November 14, 2014

**BOARD OF COUNTY COMMISSIONERS
ORANGE COUNTY, FLORIDA
ADDENDUM NO. 2 / IFB Y15-721-EZ**

**ORANGE COUNTY CLARCONA HORSEMEN'S PARK KITCHEN AND REC BUILDING HVAC
REPLACEMENT**

**FLOOR PLAN - DEMOLITION - MECHANICAL**
1/4" = 1'-0"
0 2' 4' 8'

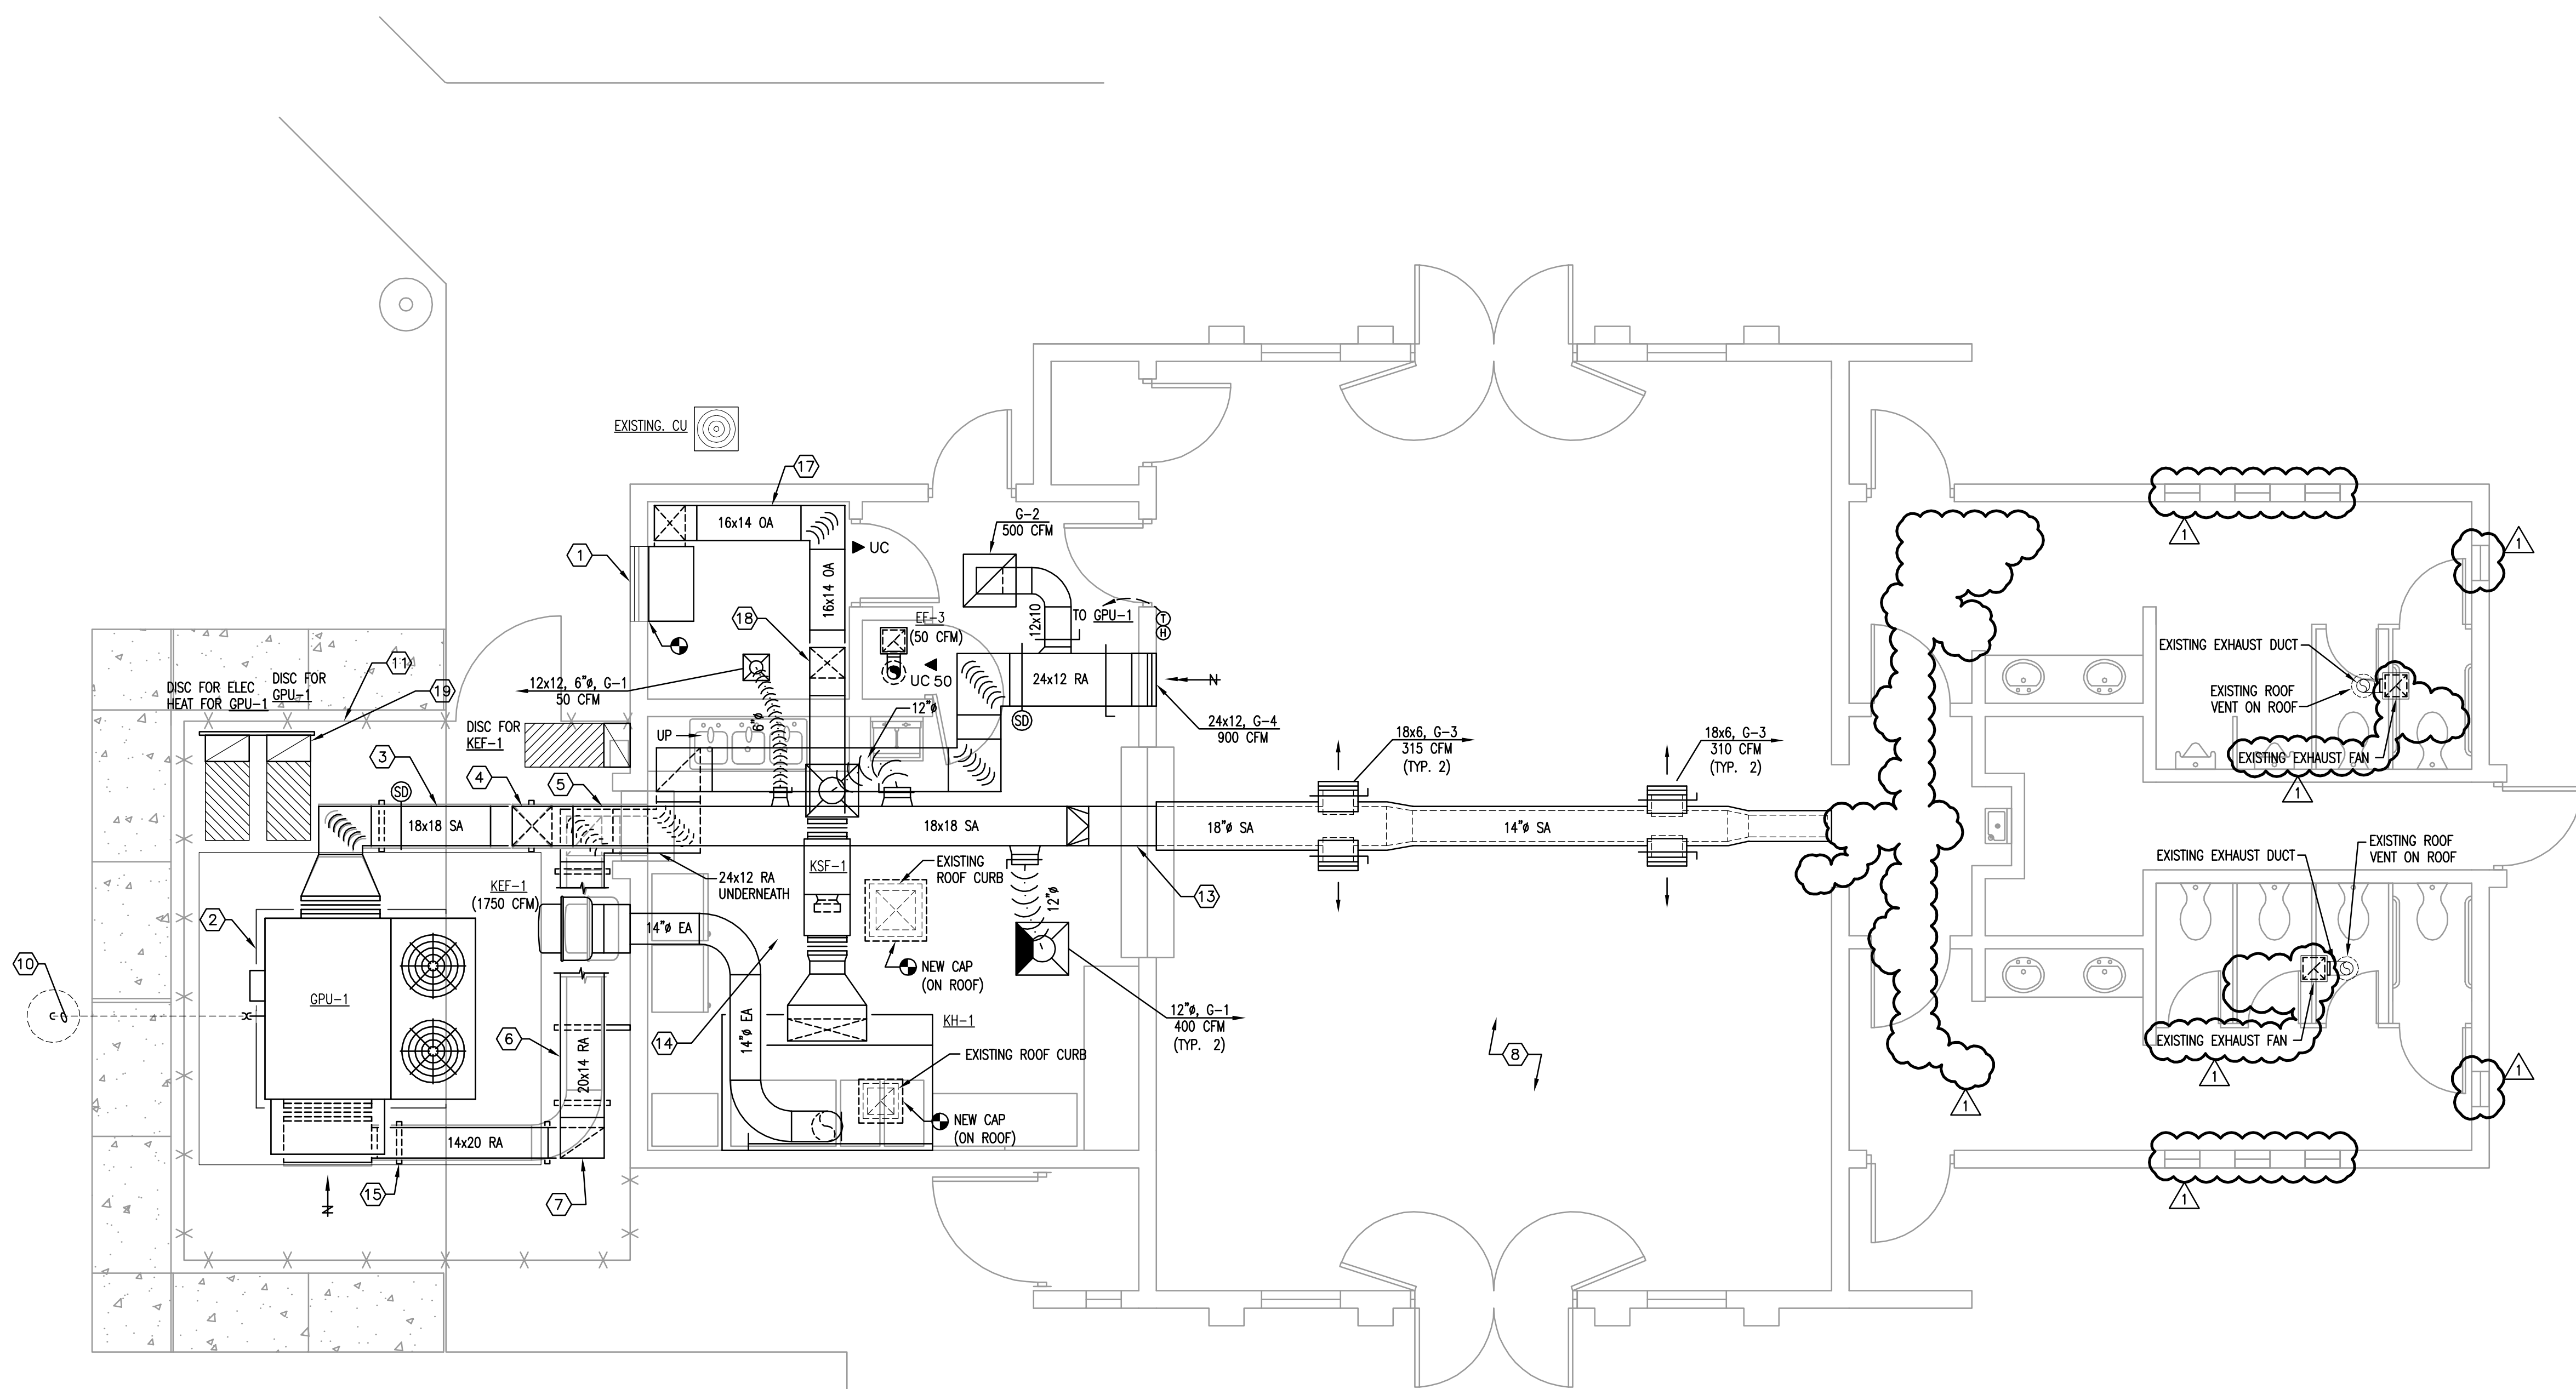
- (1) Revise exhaust fan notes in restrooms
 - (2) Revise Hex Note #9.
- l. DRAWING SHEET NO M101 – FLOOR PLAN – RENOVATION - MECHANICAL
 - (1) Revise exhaust fan notes in restrooms.

FLOOR PLAN RENOVATION MECHANICAL
 100% CONSTRUCTION DOCUMENTS
 Drawing No. **M101**

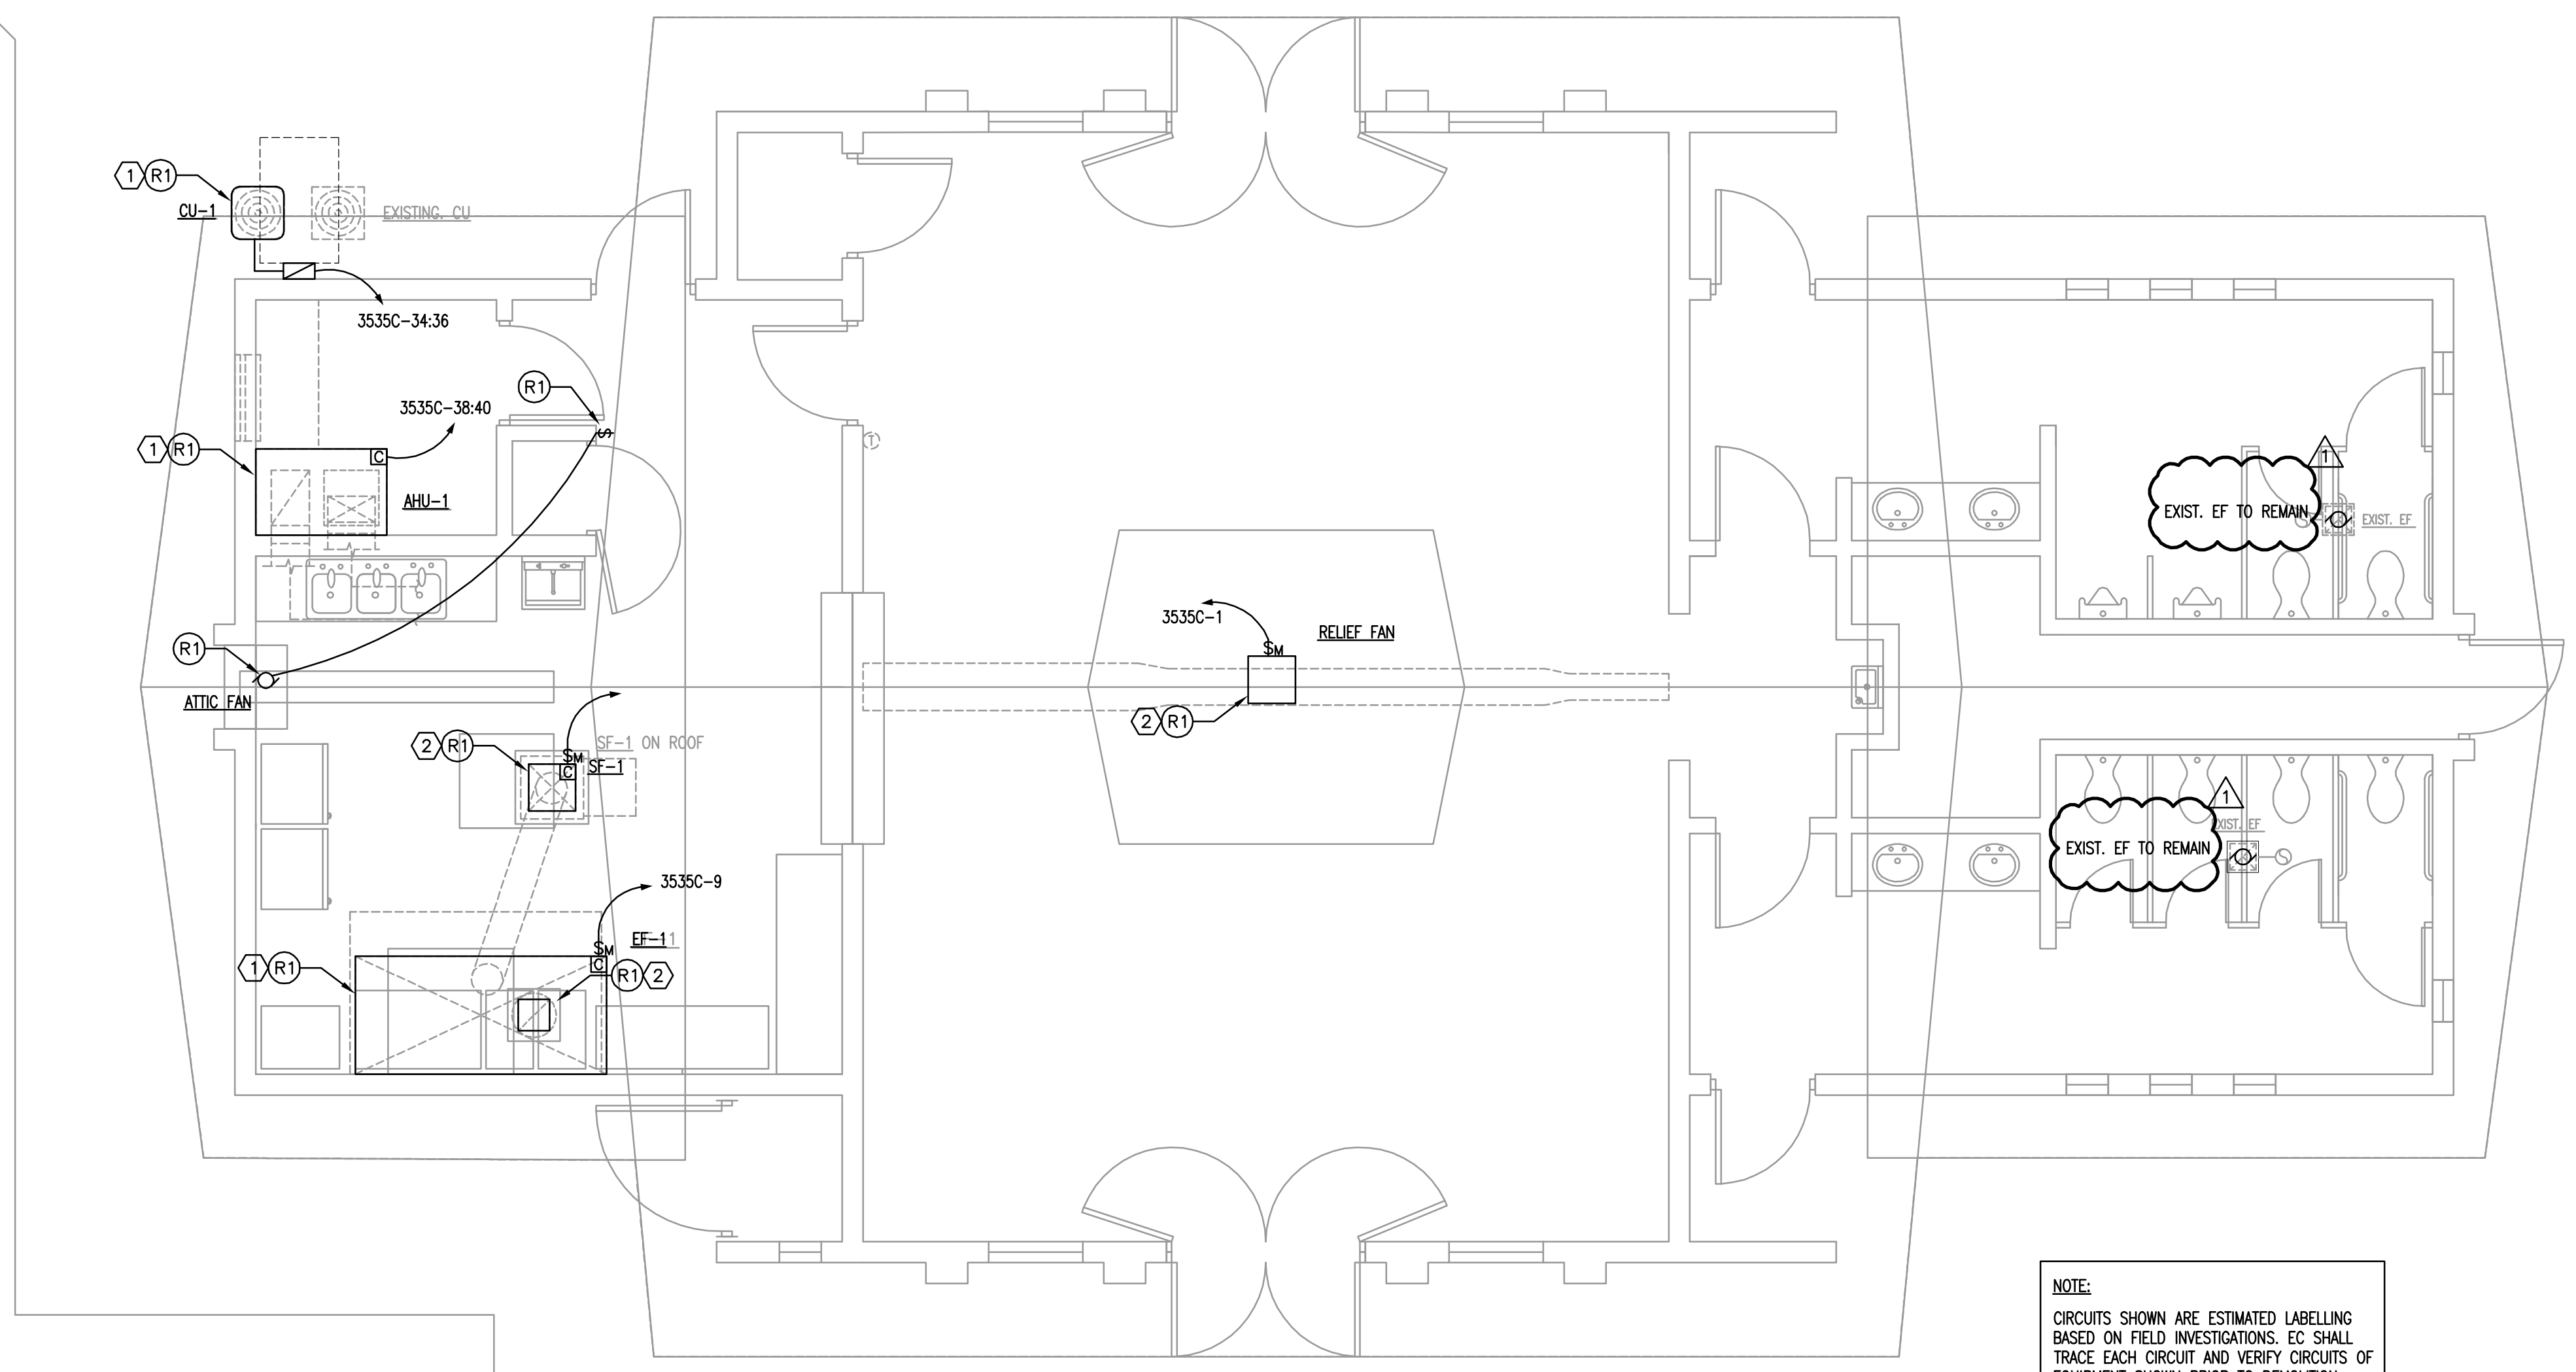
- (2) Remove restroom ductwork.
 - (3) Add General Note #21.
- m. DRAWING SHEET NO M601 – SCHEDULES- MECHANICAL
 - (1) Revise schedules as shown in attached sheet.

Drawing Title:
FLOOR PLAN - DEMOLITION - POWER
 100% CONSTRUCTION DOCUMENTS
 Drawing No.
ED101

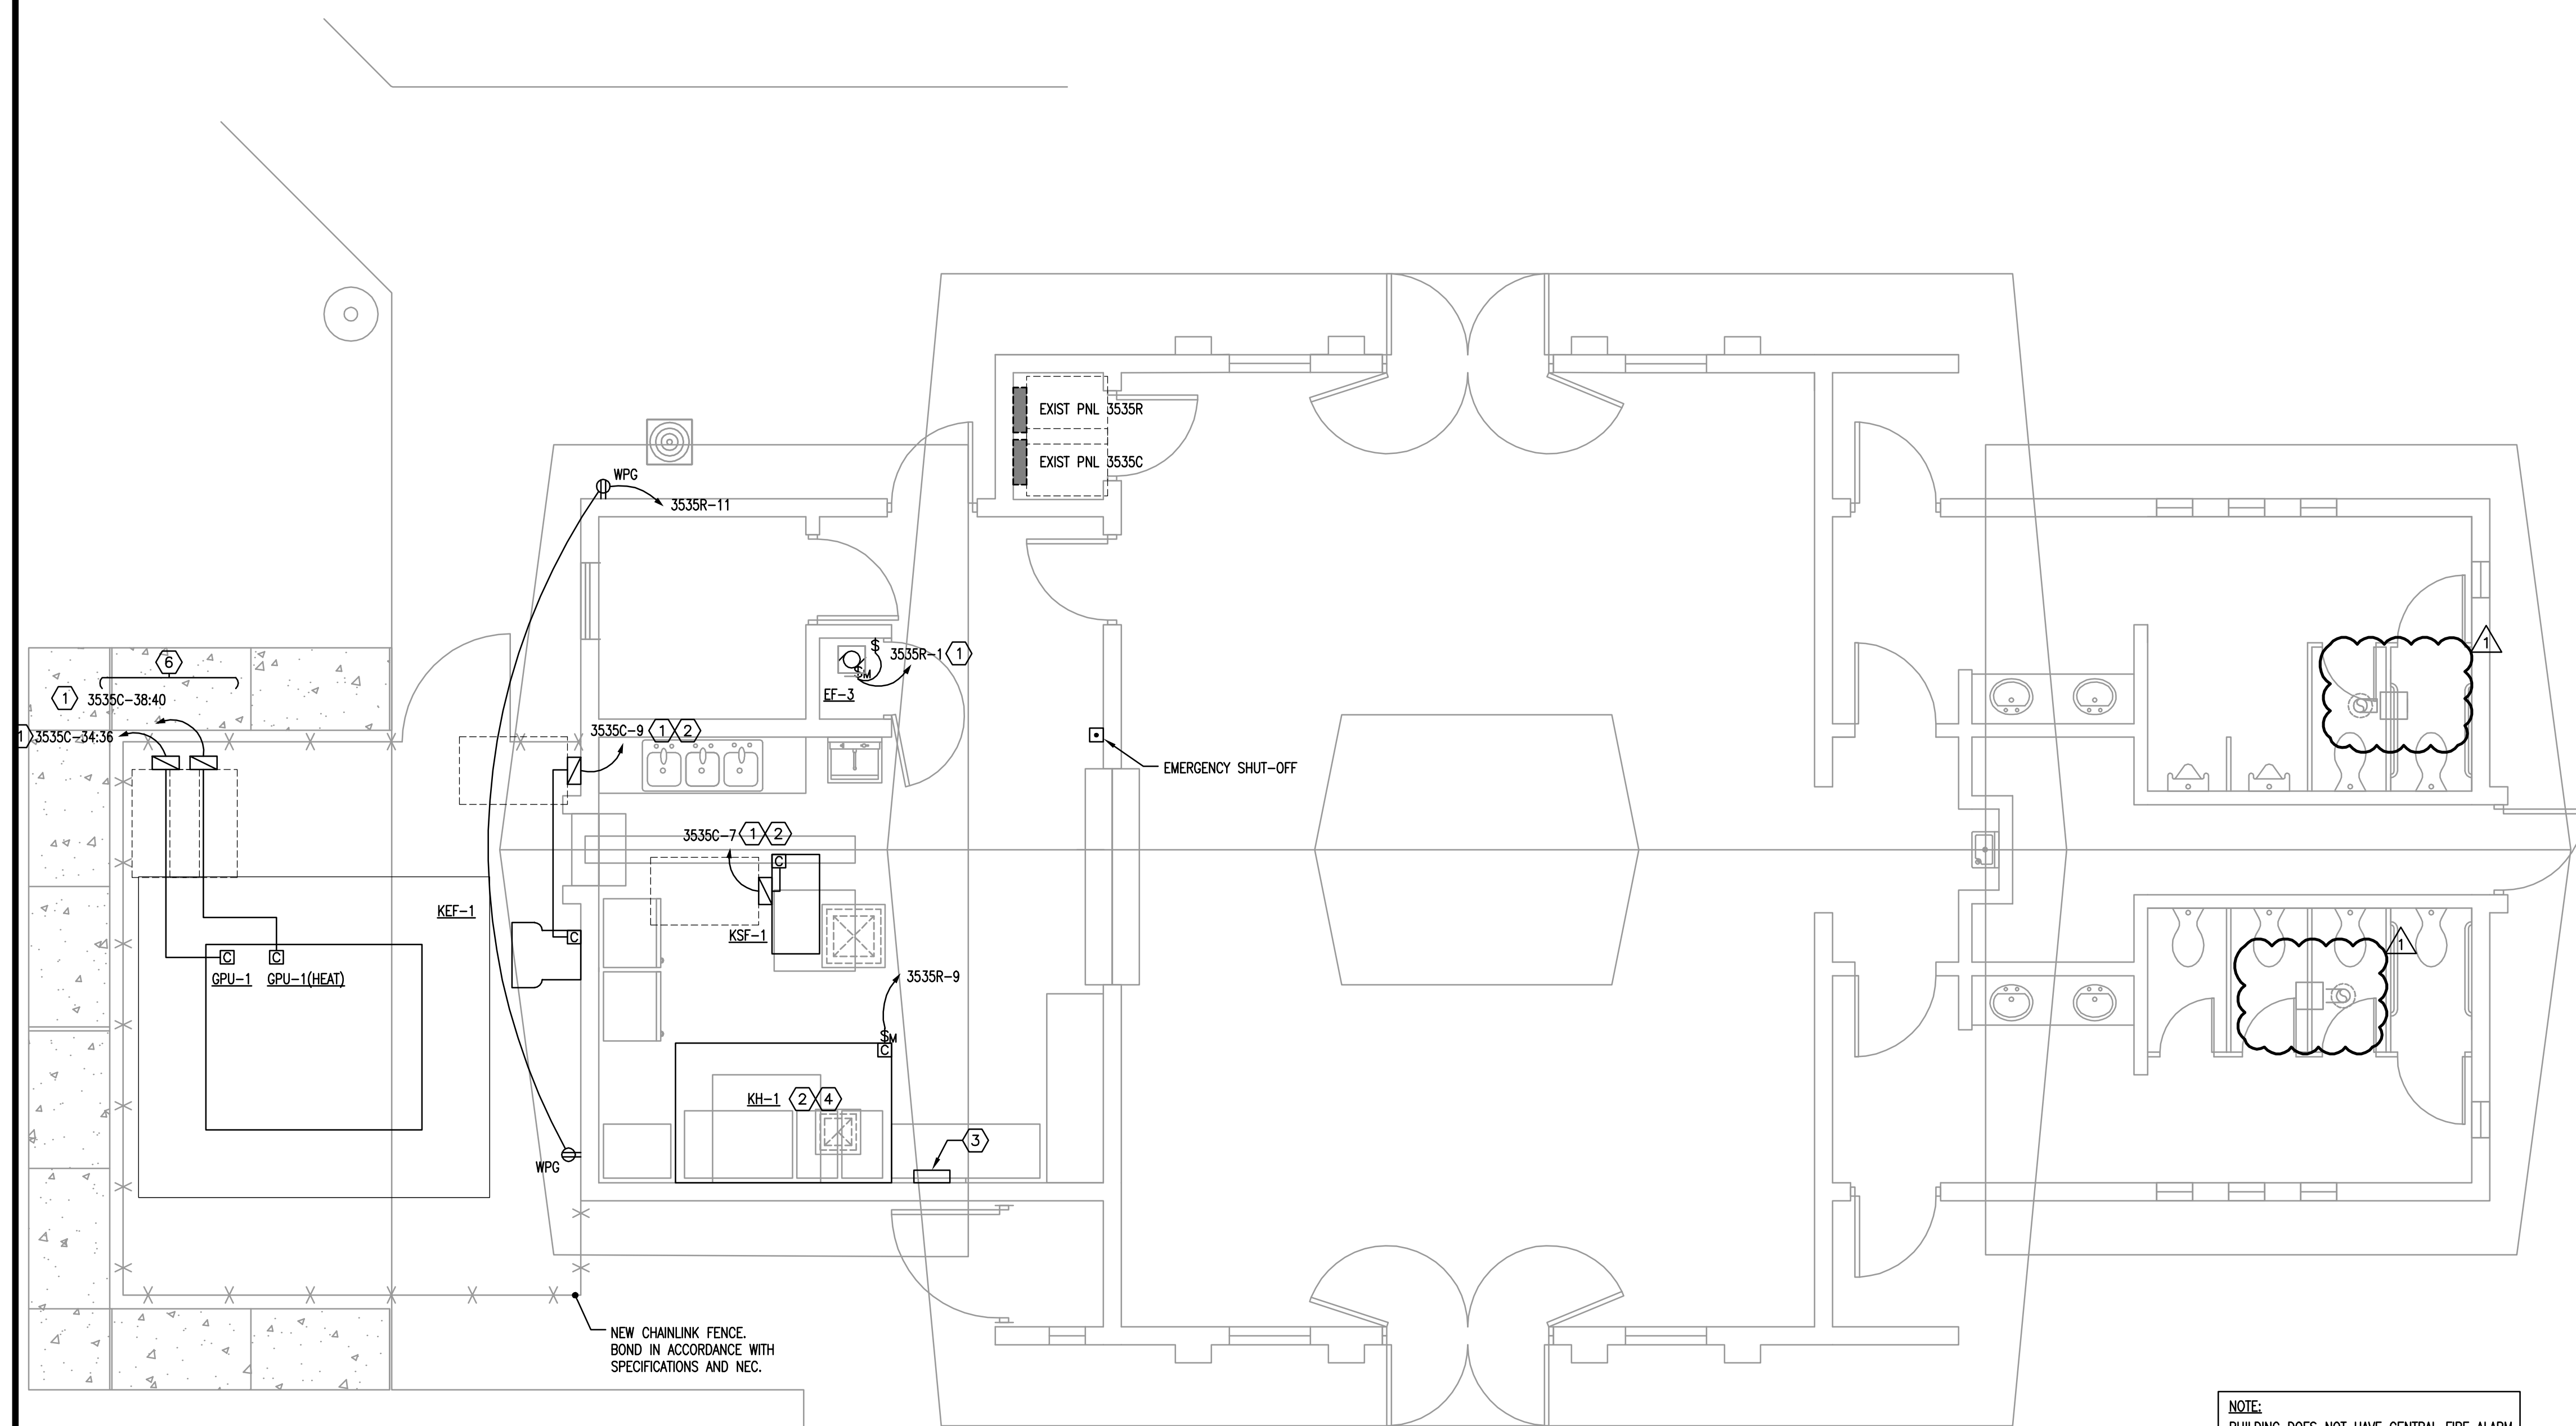
- n. DRAWING SHEET NO. ED101 – FLOOR PLAN - DEMOLITION - POWER
 - (1) Revise two exhaust fans serving restroom to show “existing to remain.”
- o. DRAWING SHEET NO. E101 - FLOOR PLAN - RENOVATION - POWER/SYSTEMS
